# Historic Landmarks and Preservation Districts Commission

### **Certificate of Appropriateness**

Case No: 23-COA-0051
Classification: Staff Review

Property Address: 2743 Virginia Avenue

Figure 1. Historic Photo showing Parkland Branch Library main entrance (Unknown source).

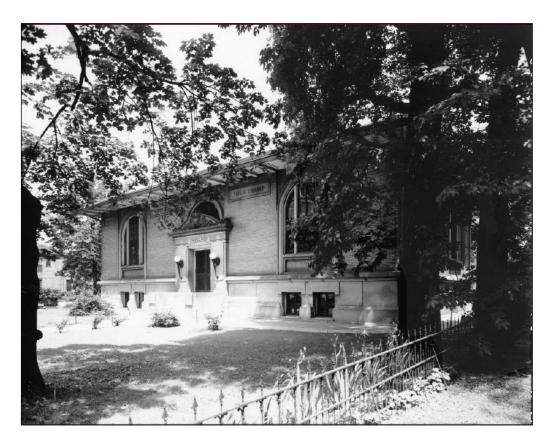
Case #: 23-COA-0051-IL Page 2 of 13 The proposed door replacement generally does not meet the applicable Individual Landmarks design guidelines for **Door**. It is unknown when the front façade double doors were replaced but the library has always had double doors. Thus, the replacement doors will remain double doors and will be placed on the same location as the existing (**Figure 1**).

- The front façade door shall be a double door that is historically appropriate to the period and style of the building. The applicant shall submit to Landmarks Staff cut sheets of the new double-entry door prior to installation.
- 2. Retain the character-defining features of a historic building when undertaking accessibility code-required work. Comply with the Kentucky building code in such a way that a historic building's character-defining features are preserved.
- 3. The new front railing shall be submitted to staff for review and approval.
- 4. Make provisions for screening and storage of trash receptacles when designing new construction.
- Use an exterior sheathing that is similar to those of other surrounding historic buildings.
